IMPORTANT SAFETY RECALL

Safety Notice**SN-658****DATE:** 5/17/207**REVISED:****TO:** Owners, Users, Dealers, and Installers**Models Affected:** C4000, FC, HR, HRX, SCM, TC, TCX, TL, TPL, XT**SUBJECT:** *GFI circuit breakers on 408 volt Hy-Power[™] units***Issue:**

Figure A

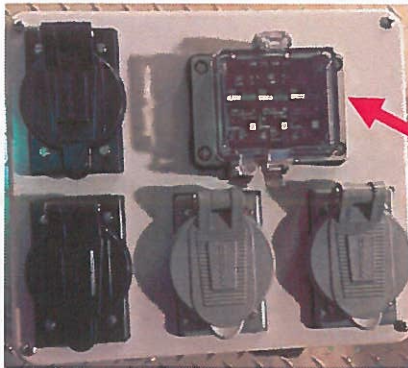
Terex Utilities has determined that 408 volt Hy-Power[™] units, built between December 2007 and September 2016, may be equipped with 110 volt AC export power boxes that contain Ground Fault Interrupt (GFI) circuit breakers not rated for personnel protection. **If a ground fault occurs while using the export power supply an electrical hazard may exist.**

1. Immediately inspect your unit by locating the export power box as shown in Figure A and inspect the circuit breakers as shown in Figure B to determine the manufacturer of the circuit breakers. Only export power boxes that contain **CBi** manufactured circuit breakers are subject to this bulletin and must be replaced.

1. Do not use the export power supply, shown in Figure A, until the GFI is inspected and replaced as necessary.
2. Open breakers shown in Figure B and Lock-Out-Tag-Out the affected export power box circuit breaker cover per your company's procedure.
3. Follow all maintenance and inspection requirements specified in the manuals.

2. Once the inspection is complete and CBi circuit breakers are identified, contact your local Terex authorized dealer.
3. Follow the Continued Use instructions in this bulletin.
4. Terex recommends you complete the replacement as soon as possible, no later than 60 days from receipt of this bulletin.
5. After replacement is complete, fill out the completion form enclosed with the owner letter and return it to the Terex Utilities Warranty Department at utilities.warranty@terex.com or fax to 1-605-882-5579.

Figure B

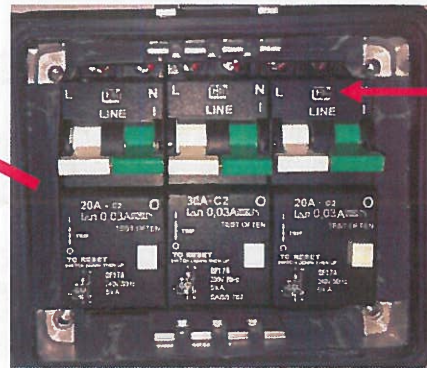
**CBi
Manufacturer
Label**
